800 STEWART

EARLY DESIGN GUIDANCE 2

SDCI#3034006-EG

11.05.2019

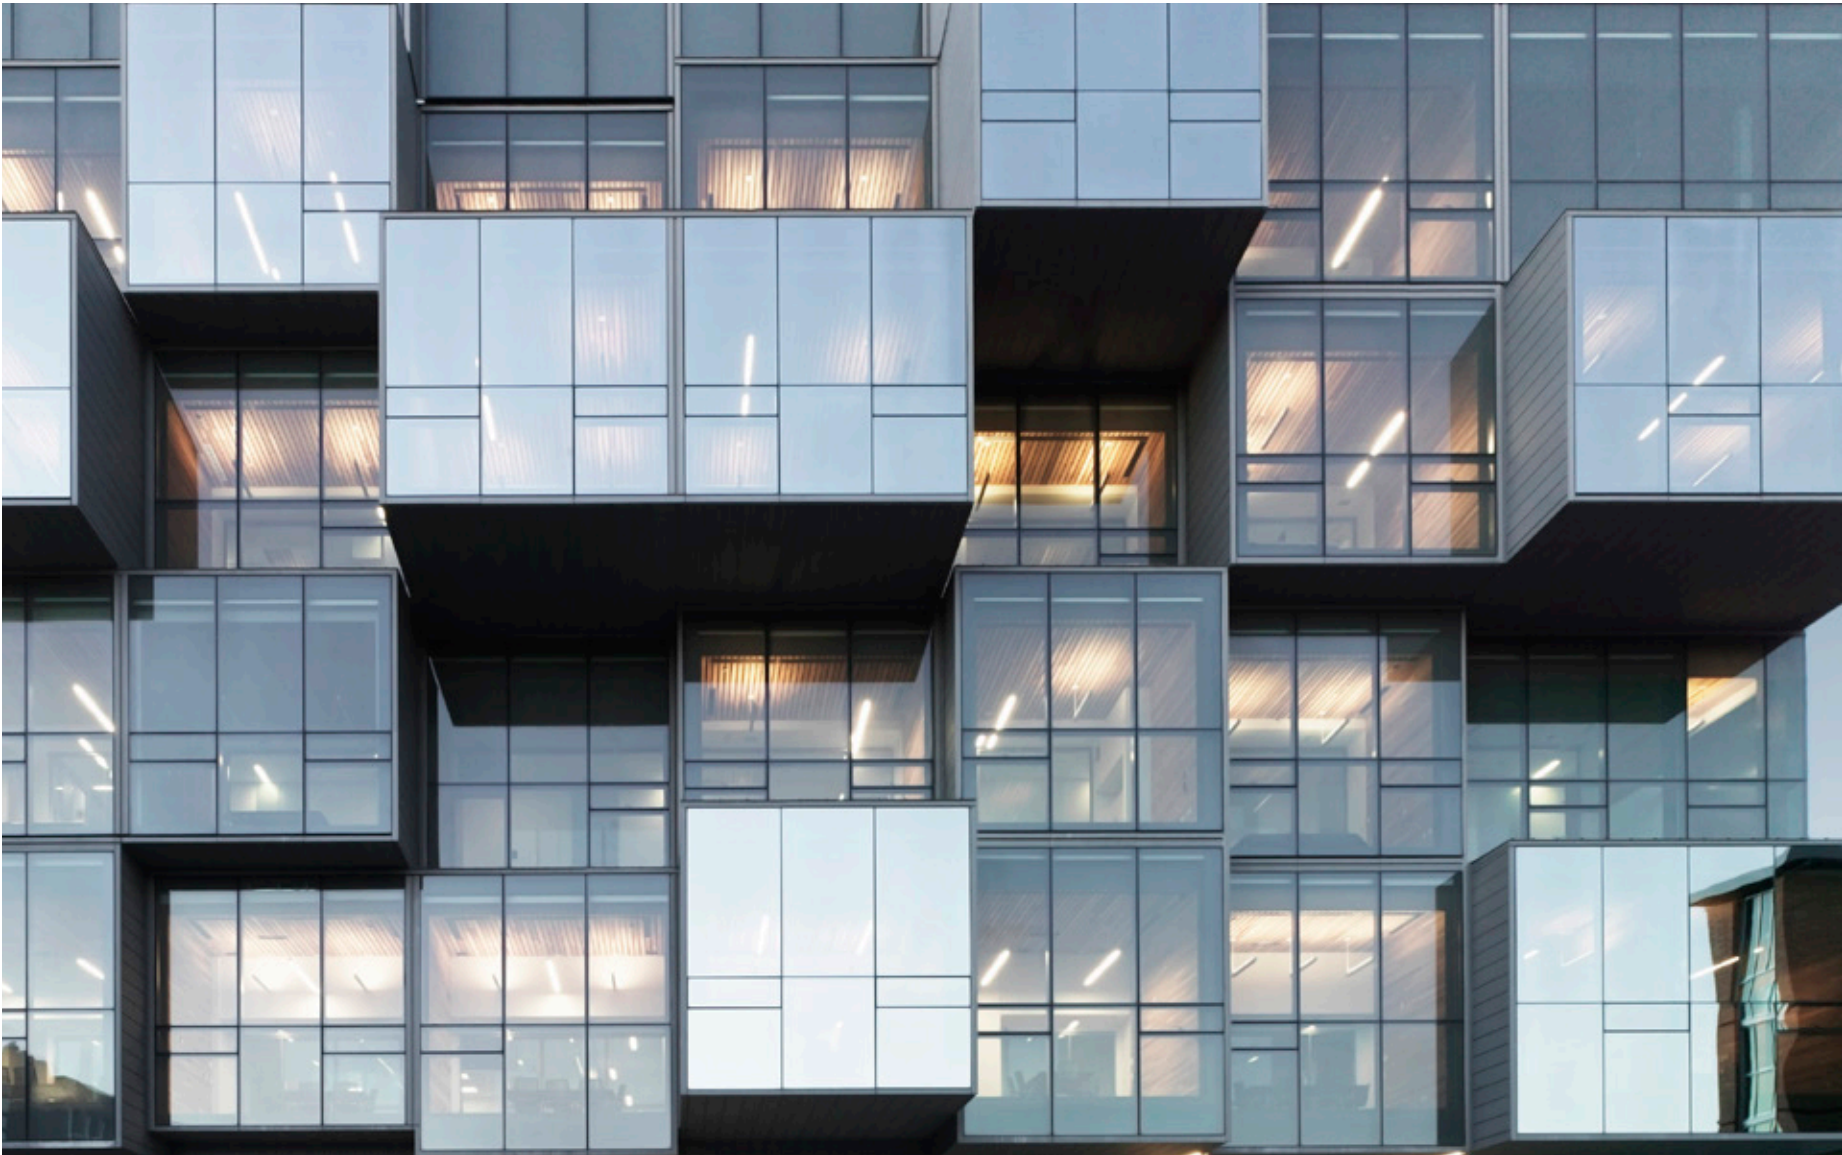
The Board noted that the glass selection (type, color, reflectivity) would be a critical element in the success of the design and encouraged the design team to carefully consider this choice and be prepared to demonstrate its efficacy at the Recommendation phase. (C-2, B-4)

The design team has performed a comprehensive study of glass selections available that meet both the design intent as well as the performance criteria for the building. The design team has chosen two “tone-on-tone” glass selections that provide an appropriate amount of reflectivity with a subtle tonal shift between the two, allowing the chamfers and folds in the tower to be more legible.

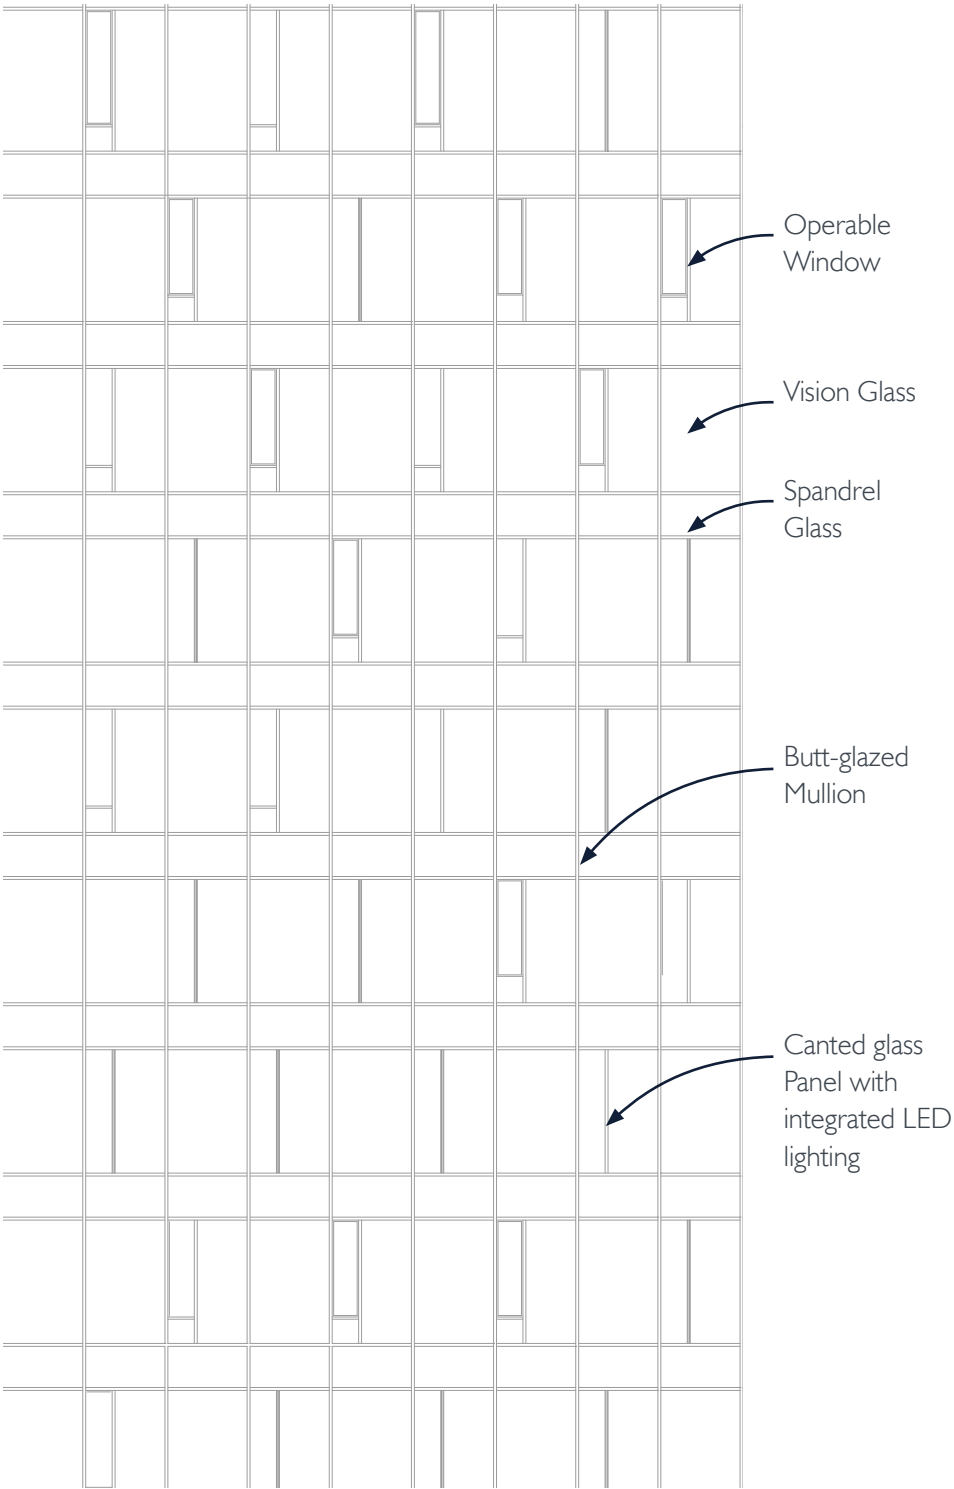
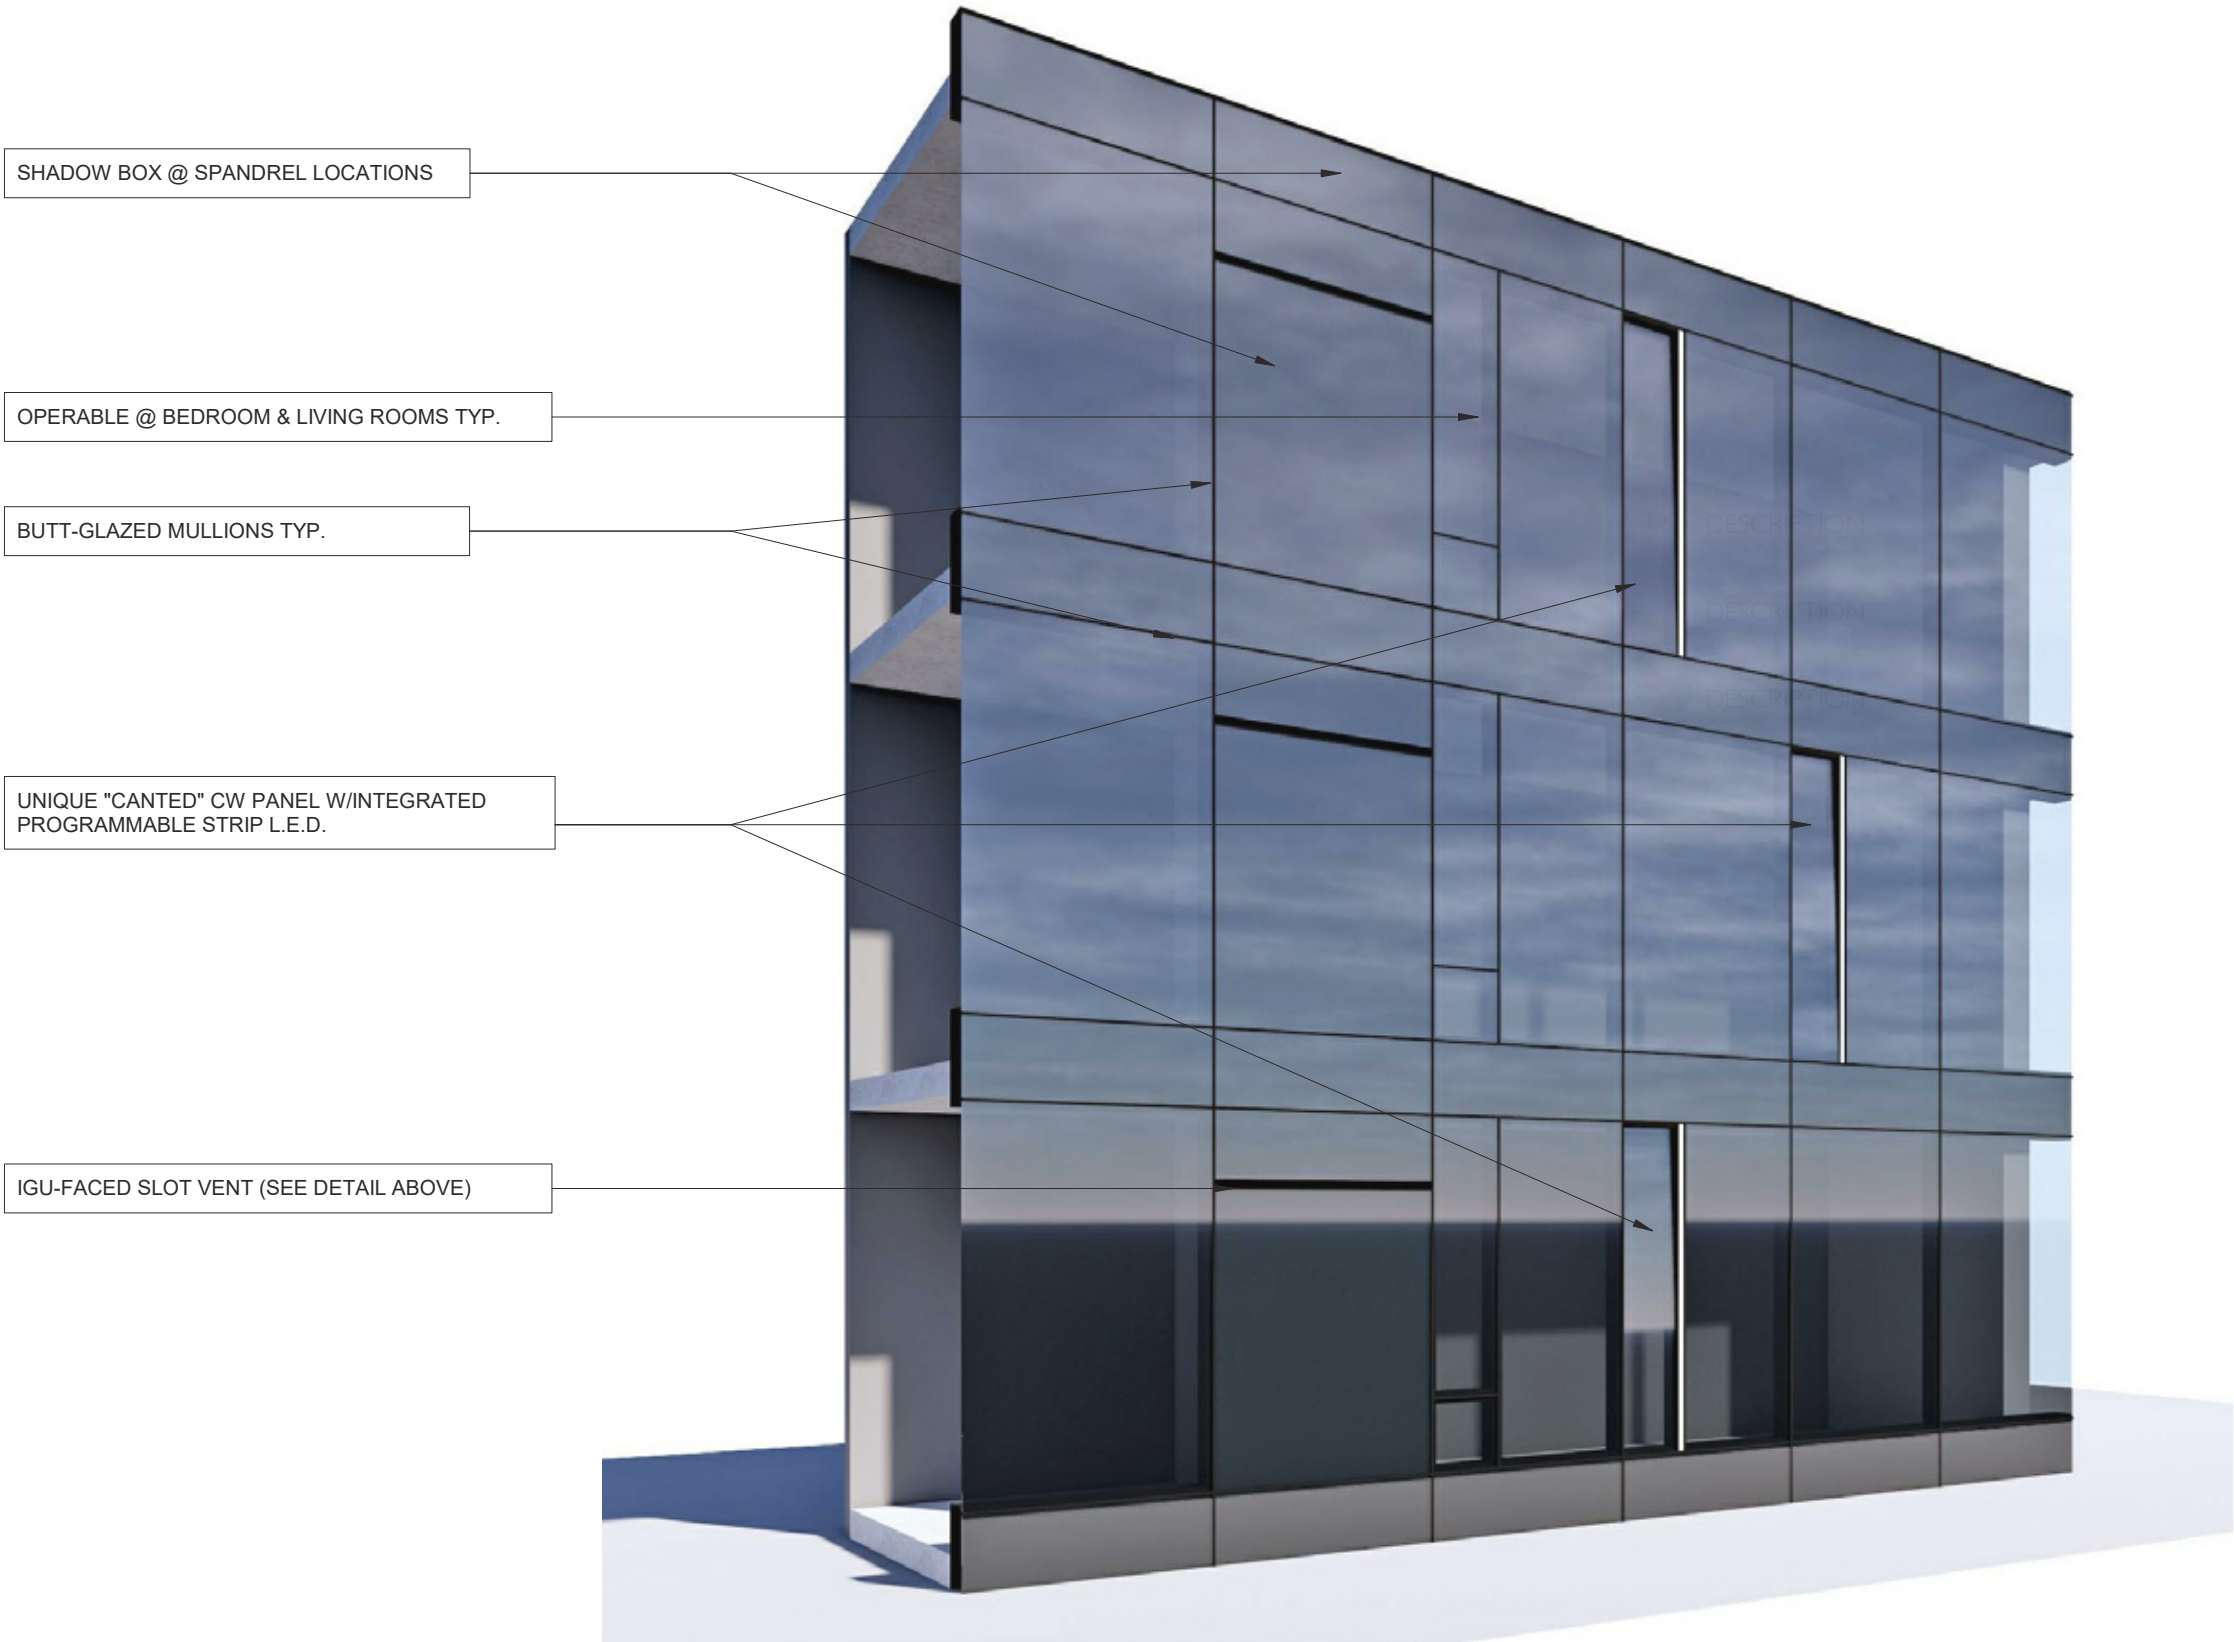
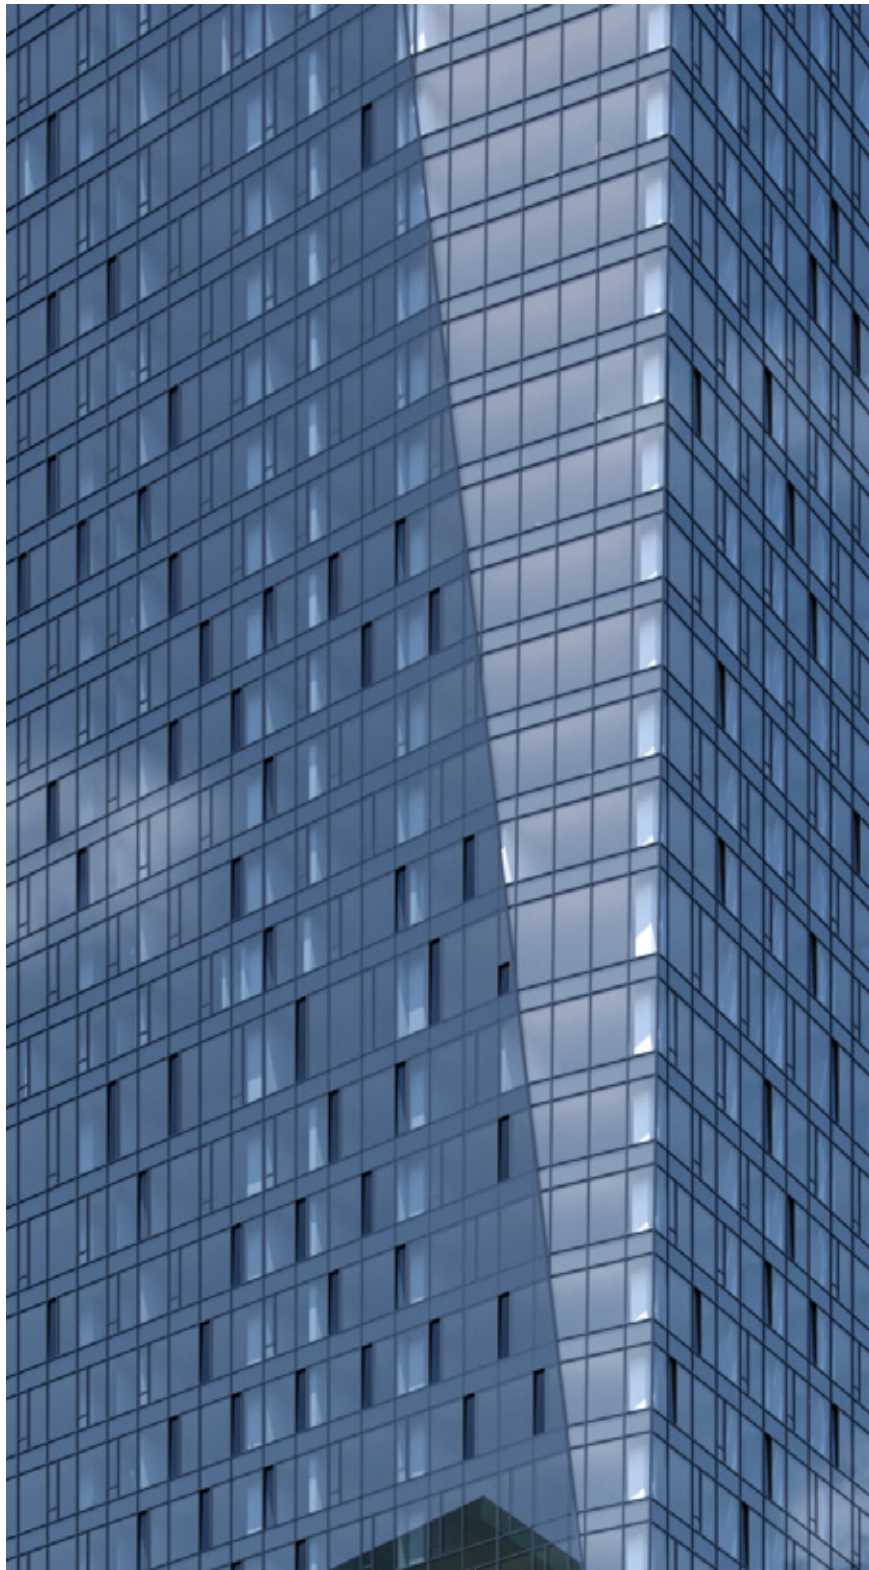
The Board agreed that there were many approaches to strengthening this design concept that could be successful, and asked the design team to specifically demonstrate responses to the following possibilities at the next EDG meeting: Exploration of the articulation, distribution and pattern of the operating windows. (B-2, B-4)

The Board supported the incorporation of operating units in the glazing system, recognizing the value their different character and distinct shadow lines could have in providing texture to the facade. The Board also supported the way these operating units would create a distinct expression for the areas of residential programing. (A-1, B-2, B-1)

Given those residentially programmed areas, the Board noted the impact interior lighting will have on the building's night-time appearance and asked the design team to carefully consider and demonstrate a design response to this issue as the design develops. (B-4)

The design team has further refined and articulated the facade treatment, especially relating to the pattern of the canted (fixed) panels and configuration of the operable panels to provide additional texture and depth to the facade. The design team has also studied the integration of the exterior lighting into this patterning and the impact of interior lighting on the design expression at these areas.
